From: [EPAPanningLiaison](#)
To: [EPD, Customer Services](#)
Subject: Declined: 25 & 26/43 O"CONNOR -10:45 - Pre App Mtg - 201732362

Pre-Application Meeting Notes

BLOCK/S:	25 & 26	PROPOSAL NUMBER:	201732362
SECTION:	43	DATE OF MEETING:	22 August 2017
SUBURB:	O'Connor		
PROPOSAL:	Demolition, consolidation of two blocks, multi unit development (8 units)		
EPSDD CONTACT DETAILS:	Matt and Kym DA Gateway Team planningenquiries@act.gov.au 02 6205 2888		
PROPONENT:	Philip Leeson Architects		
OTHER ATTENDEES:	Brooke Yates – CSD, Housing Architect - Philip Leeson Architect		
ENTITY ATTENDEES:	TCCS – Asset Acceptance TCCS Urban Treescapes Icon Water

What is the proposal	Demolition of existing duplex, consolidation of 2 blocks, construction of multi-unit housing comprising 8 units in a 2 storey building over basement car parking, with new driveway verge crossing in existing location. Variation of lease to allow 8 units.
Is there a Crown lease	Yes – Residential purposes
Use/s permissible under lease	Yes
Zone/s	RZ4 – Medium Density Residential Zone
Use proposed	Multi unit residential use
Is use permissible in zone	Yes
Development codes	Residential Zones Development Code Multi Unit Housing De

Site Analysis Plan & Rear Zone Site Coverage Comparison

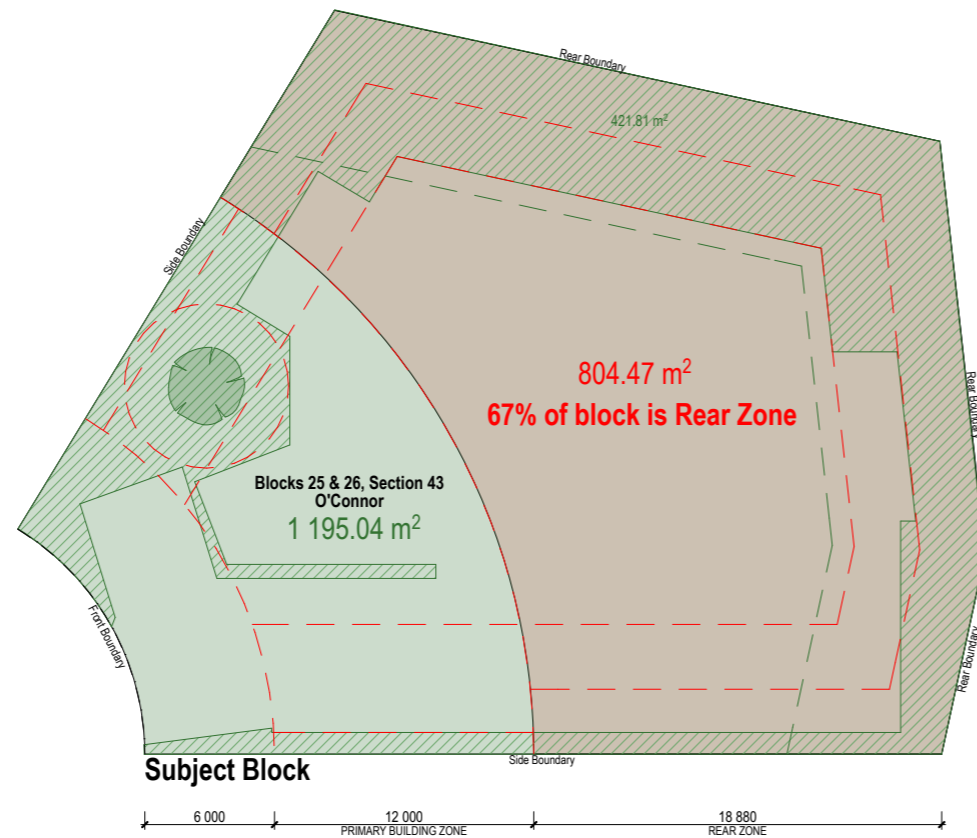
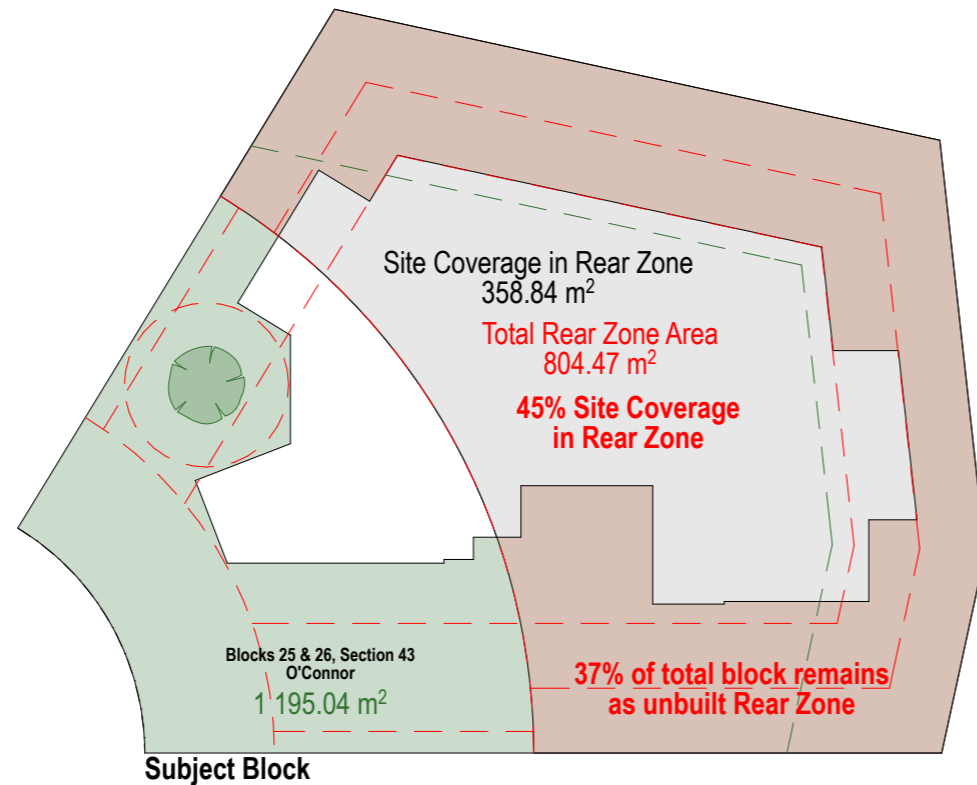
Assess statements against criteria on Site Analysis Plan SK05:

C8 of Inner North precinct Code - Rear setback

C13 of Inner North precinct Code - Site coverage

ACTEWAGL confirmation will be required that demonstrates that access being provided to power easements and poles at the rear of the site is sufficiently addressed by using removable fence panels as shown on the site plan.
